Informal document GRSP-63-13  
(63rd GRSP, 14-18 May 2018  
agenda item 13)

# CLEPA analysis of belt contact width measurement (ref. GRSP/2018/6)

63rd GRSP session, 14-18 May 2018  
Palais des Nations, Geneva

*Examples how to measure certain cases:  
(Cross section of the belt)*

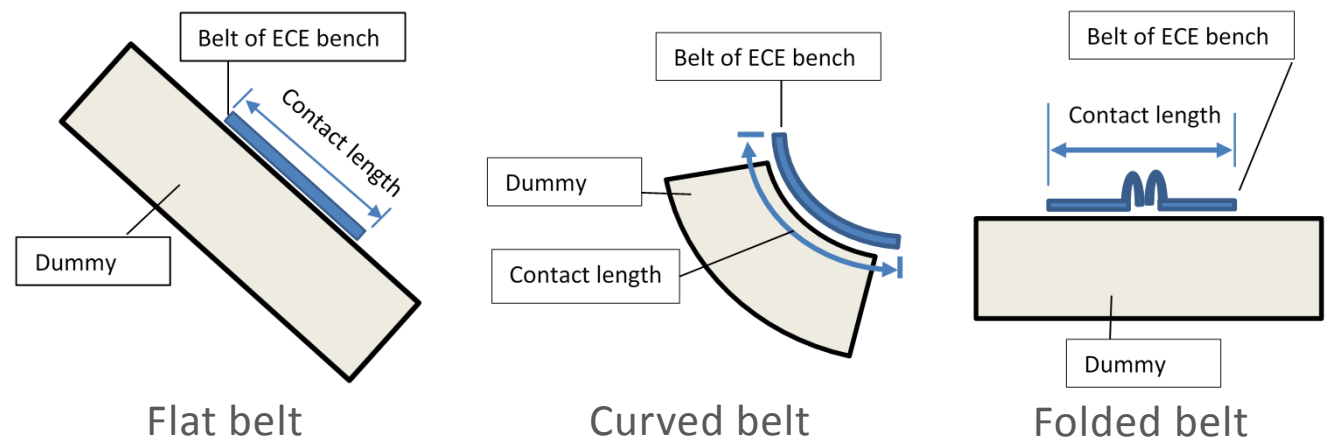
- The dummy is installed on the test bench acc. to the procedure described in R44 for a dynamic impact test
- The belt width at the first and last point of contact with the dummy needs to be measured (**two measurement points**) →
- The measurement shall be carried out by inserting the measure tape under the belt and slide it towards the dummy until the belt begins to contact the dummy.

- General:
  - First contact of the belt with dummy is a spot whose definition is subjective, but regardless of the selected spot all tested CRSs pass the requirement

- Definition of measurement spots is subjective
- Procedure needs to be improved with regards to feasibility and consistency
- Measurement seem to add no value in assessing child seats as all tested CRS achieve similar values

Belt width @ simulated buckle

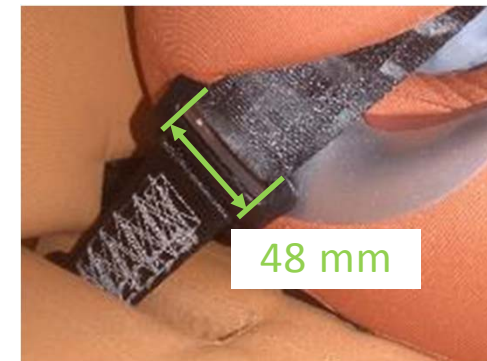
- Lap belt:
  - Contact area on buckle side might be covered from shoulder belt

Suggested measurement

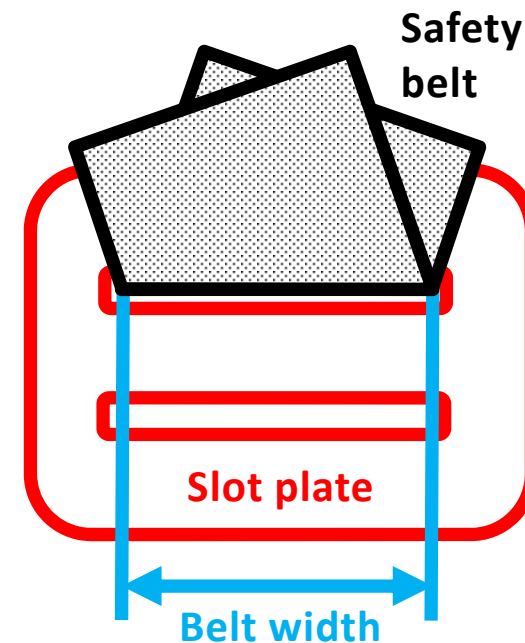
- Lap belt contact width shows clear difference between two types of booster seat designs.
- The slot plate provides a suitable reference for measurement and allows good accessibility.

To assess the contact width of the lap belt it is proposed to measure the belt width at the slot plate of the simulated buckle.

Figure 1 - Suggested measurement

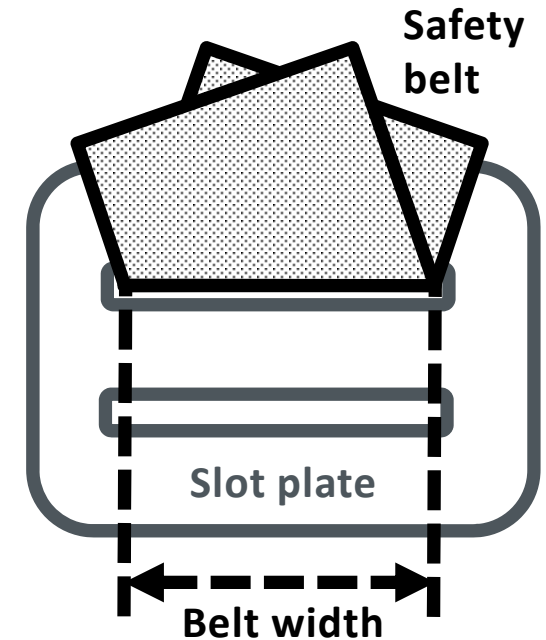
- (a) pass through the fixture points or belt guides of non-integral child restraint systems, or
- ~~(b) permit a lie of the belt that leads to any contact narrower than 38 mm between the adult belt or simulated buckle and the child,~~
- (b) permit a lie of the lap belt within the slot plate that has a width narrower than 38 mm as described in Figure 1**

In the case of ~~non-integral child restraint systems~~ booster seats and booster cushions, the ease with which the straps and tongue of an adult belt pass through the fixture points shall be examined.
